**#1005238 COORS CORRIDOR PLAN**

COMMENTS INCLUDED IN MATRIX

**RE: MPO Staff Comments for the Coors Corridor Plan Update**

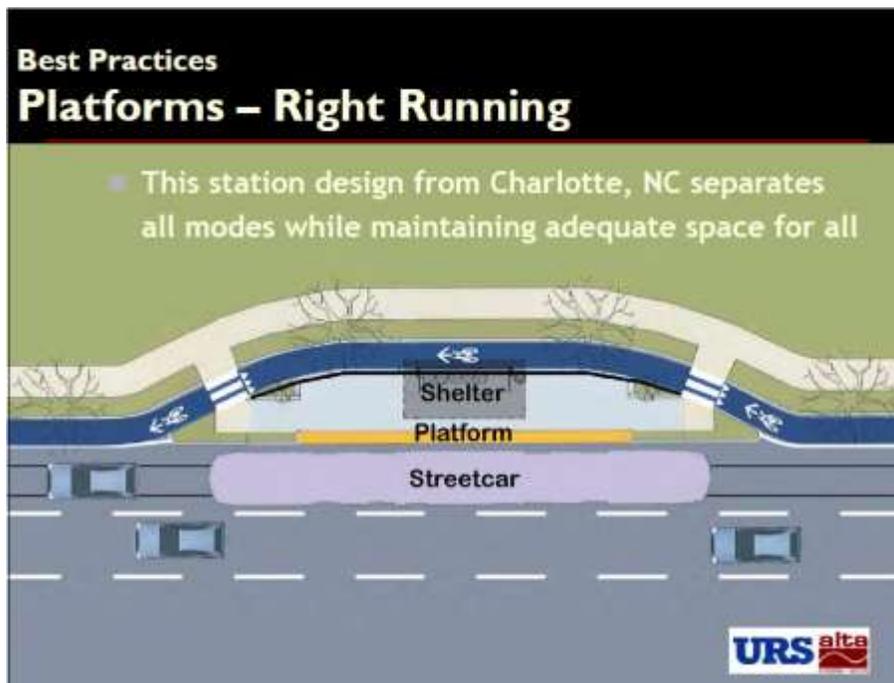
Coors Boulevard is an excellent candidate for a cycle track given its limited access. Coors Boulevard is a high speed roadway making it more important to provide a buffer between traffic and bicyclists. A dedicated cycle track would help to provide that separation and allow bicycling to be a viable transportation option to a much larger segment of the population.

MRMPO's preferred cross section including a cycle track would be ordered:

1. Sidewalk
2. Buffer
3. Cycle track
4. Buffer
5. BRT
6. General auto lanes

At intersections the cycle track would need to meet a mixing zone. There are two typical mixing zones: The first directs the bicyclist to mix with the right-turn-only lane. The second has the cyclist mixing with pedestrian traffic on the adjacent sidewalk. If the right-turn-only lanes are designed so vehicles have to significantly slow down prior to turning right, bicycle traffic could mix in that area. If this is not the preferred roadway design, MRMPO recommends the second, sidewalk mixing option.
